Year 2 Monitoring Report

MOCKINGBIRD SITE

NCDMS Project # 100021 (Contract # 7185)
USACE Action ID: SAW-2017-01505
DWR Project #20171040

RE: Mockingbird Site: Year 2 Monitoring Report (NCDMS ID 100021)

Figure 2 - CCPV MY2

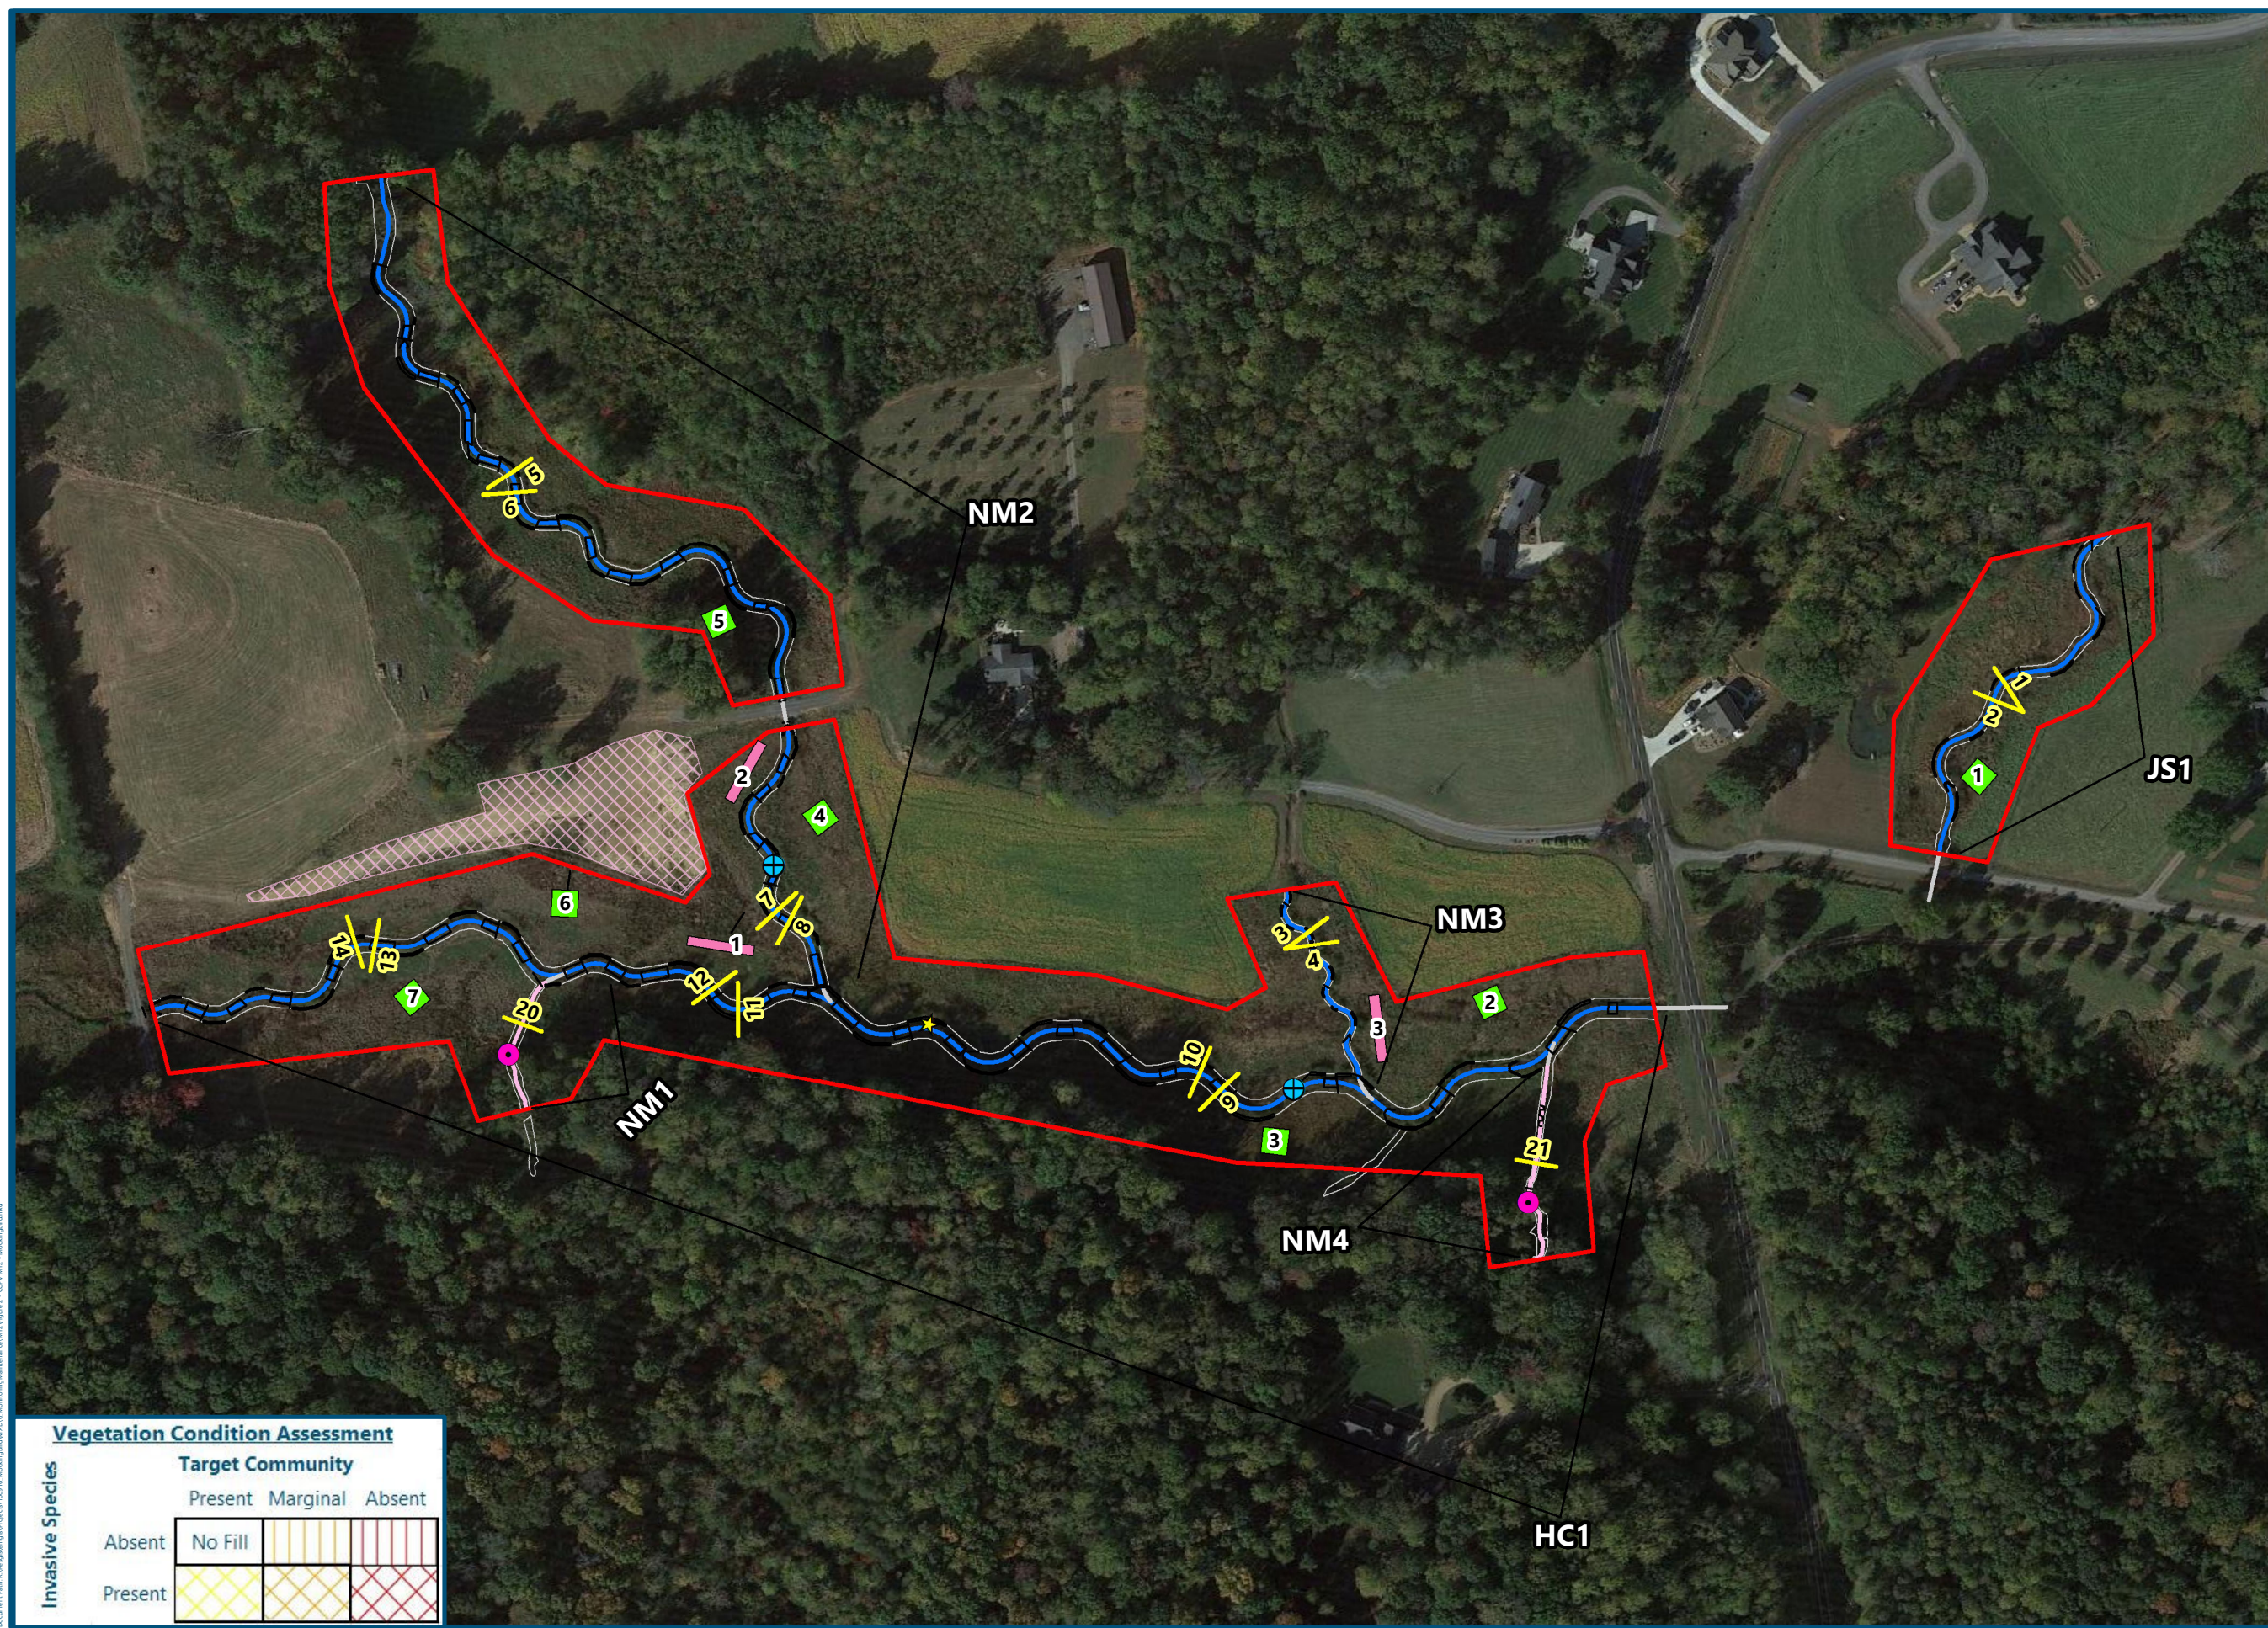
3. Performance standard table (page 4) indicates that a runoff attenuation structure will be inspected semiannually; can RES indicate where this is on the CCPV and give an update on the condition.

The two ESPs are shown on the CCPV on TP2 and TP3. The ESPs are in good condition and working as designed. Photos will be included in MY3.

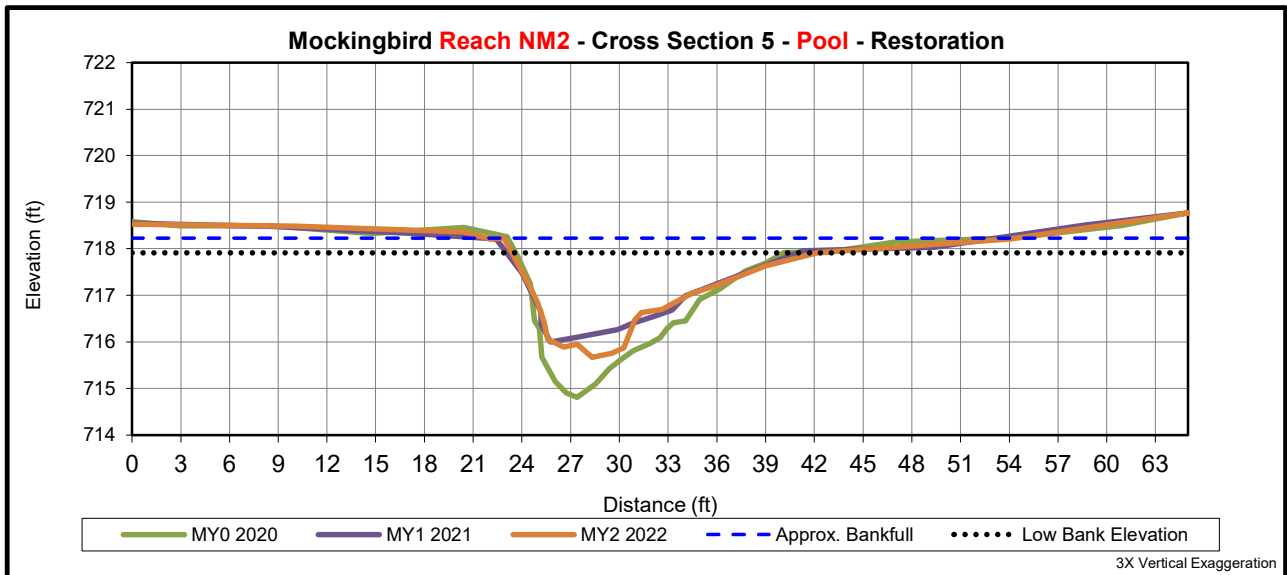
5. Cross section 5 and 17 showed some variations from MY0 to MY1; can RES comment on their MY2 condition and how they might be trending?

Cross section 5 and 17 only showed minor variations between MY0 and MY1. The MY2 conditions are stable and should continue to function properly.
